DEVIATION REQUEST AND DECISION FORM

Project Name : Cimarron Hills SE Mixed Use Filing No 1 - Subdivision
 Schedule No.(s) : 5408007001, 5408007003, 5408007004
 Legal Description : See Submittal

SUBDIVISION CONCEPT PLAN

CIMARRON HILLS SOUTHEAST
MIXED USE FILING NO.1

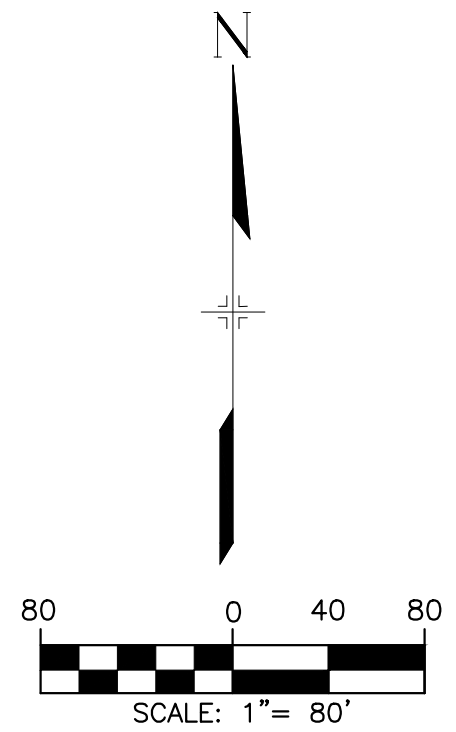
MEADOWBROOK PKWY
TIE-IN PROPOSED
WHERE FULL PETERSON
RD MEDIAN EXISTS
MEDIAN TERMINATES
TO THE NORTH

ADAQUATE INTERSECTION
SPACING WITHIN PROPERTY
LIMITS TO ADHERE TO 0.25
MILE REQUIREMENT COULD
NOT BE ACHIEVED

LIMITED SPACE TO MAKE UP A
400' ROADWAY SHIFT FROM
MEADOWBROOK PKWY STUB TO
PETERSON RD CONNECTION
POINT
